M4 Junctions 3 to 12 Smart Motorway

Non-Material Change Junction 6 No Through Junction Running Technical Note

Document Number: HA514451-CHHJ-GEN-SZ-ZZZZZZZZ_Z-TN-KK-0030

April 2022

Figure 2 Junction 6 Eastbound AM peak flows

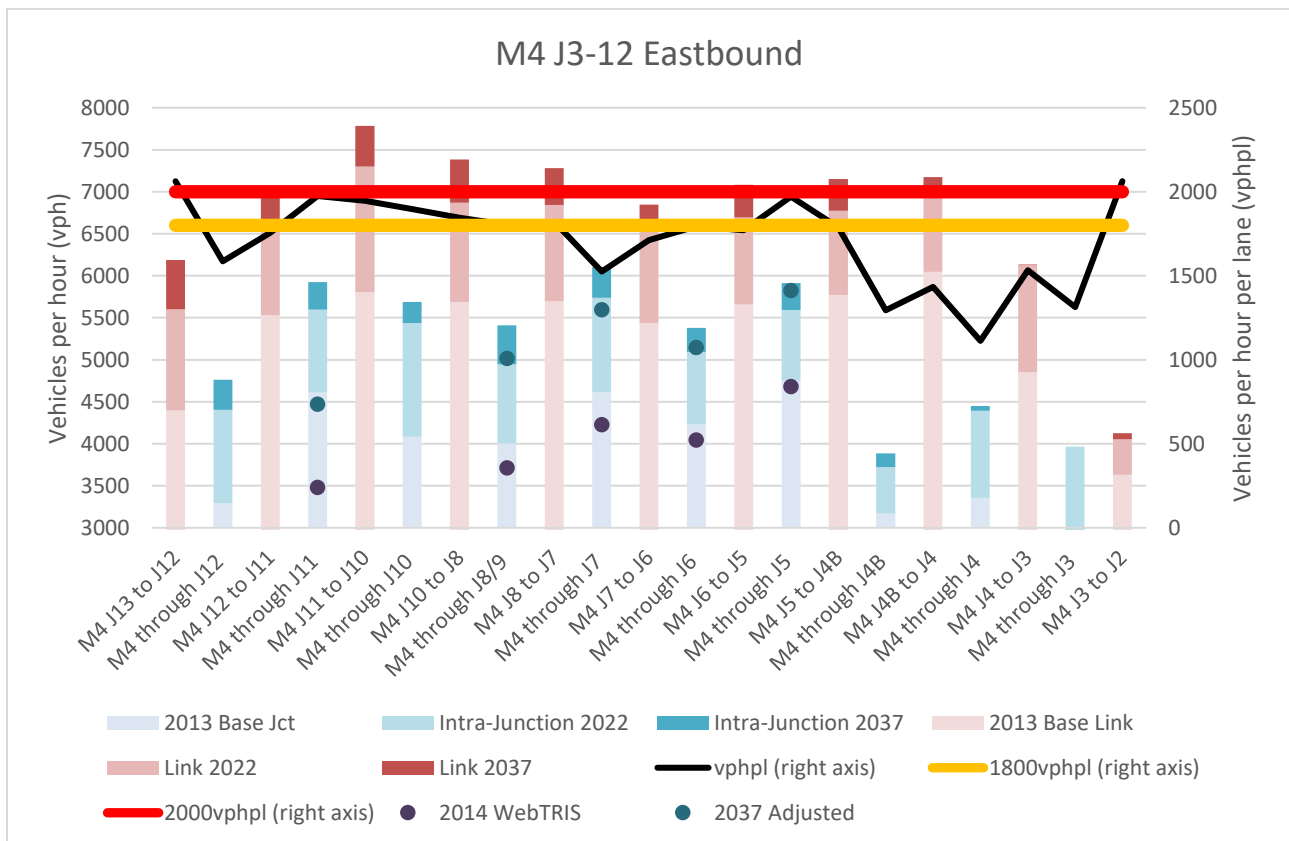
The traffic model data indicates that the intra junction flows without TJR (three lanes) will 5095 vph (i.e. less than 1800vph per lane) compared to 5215vph with TJR in the opening year and 5380 vph (i.e. less than 1800vph per lane) compared to 5555vph with TJR in design year (2037). The merge slip road has forecast flows of 1600vph in the opening year and 1700vph in the design year, and this high merge flow may be better suited to a lane drop/lane gain arrangement (No-TJR) layout associated with No TJR on an ALR scheme.

Figure 3 Westbound PM peak flows

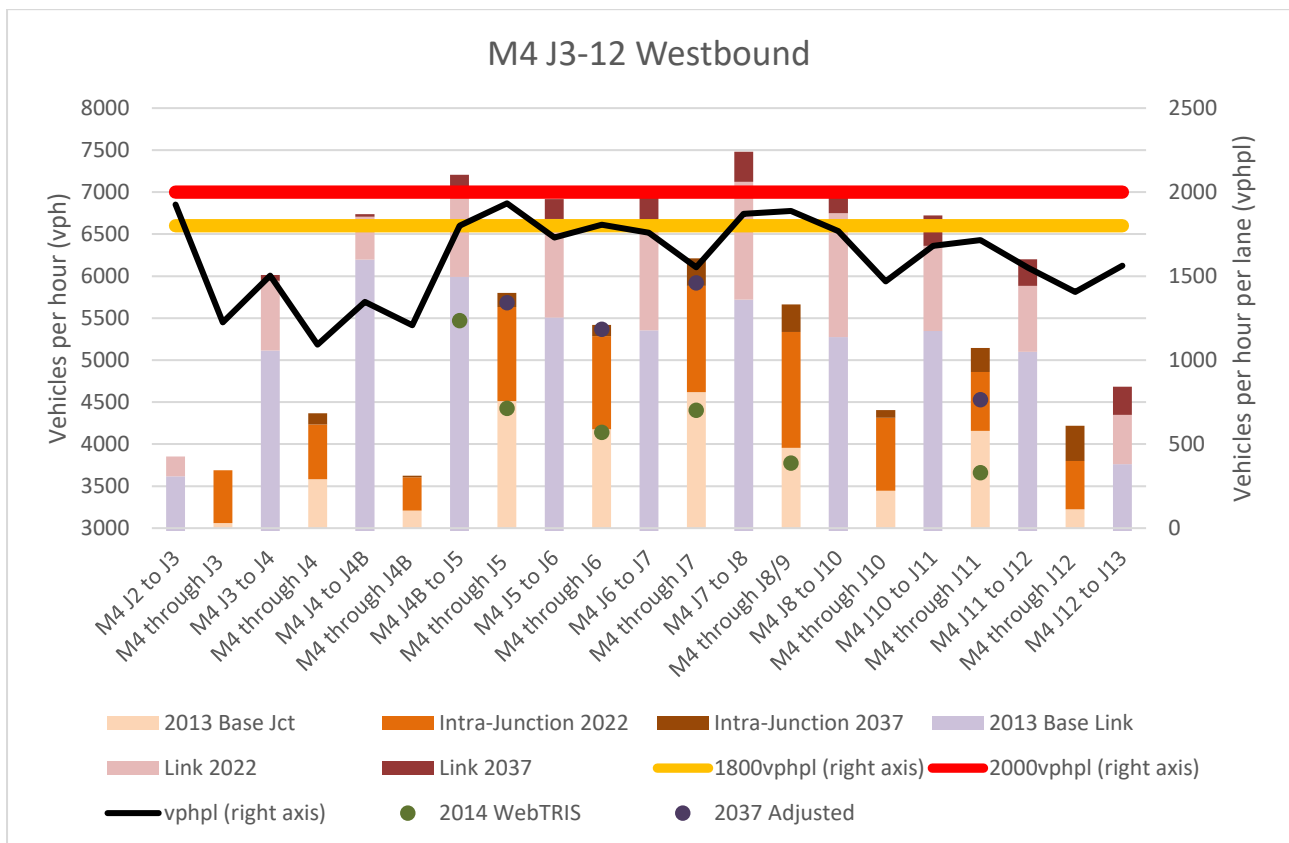
The traffic model data indicates the intra junction flows without TJR (three lanes) will be 5285 vph (i.e. less than 1800vph) in the opening year, and 5415 vph (i.e. marginally more than 1800vph per lane and less than 2000vph per lane) per lane in the design year.

Figure 5 Schematic showing layout with junction 6 without TJR

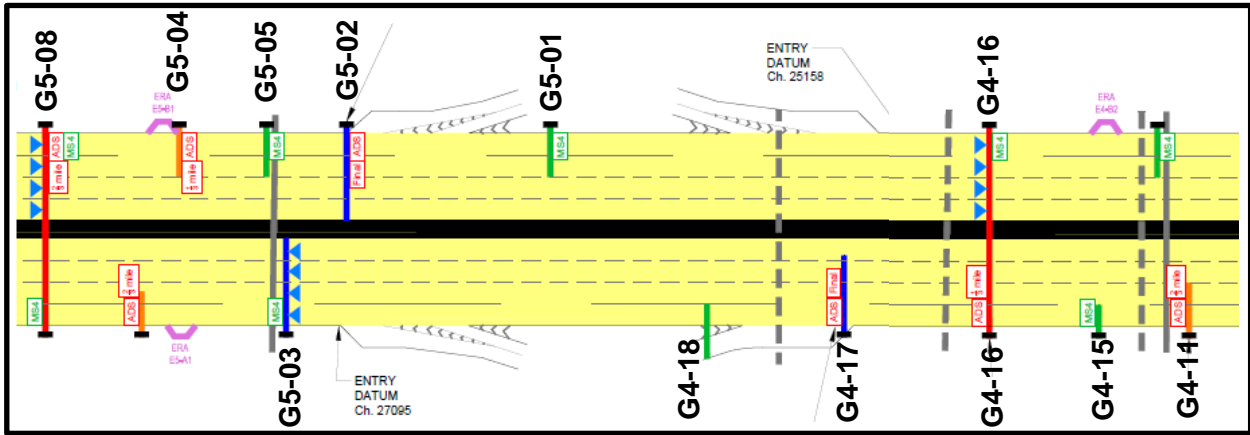
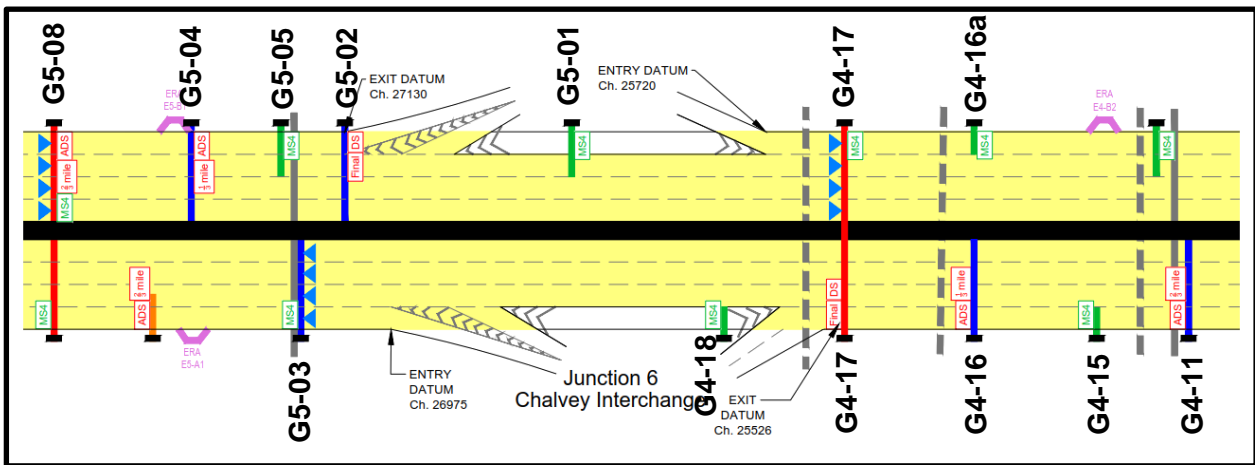
Figure 4 shows a schematic of the previously proposed location/order of gantries on both approaches to junction 6, whereas Figure 5 shows the new proposed layout of junction 6 (with no TJR).

The details eastbound and westbound gantries are provided in Table 2 and Table 3 respectively. The changes to gantry location between TJR and No TJR are shown.

The junction is proposed to run as No TJR. Three lanes and a hard shoulder in each direction will remain through the intra-junction, i.e. Dual 3 Lane Motorway (D3M). The retention of hard shoulder through the junction will provide a place of relative safety.

This proposed change to NTJR will no longer require any widening to Windsor Rail Bridge to the east of junction 6.
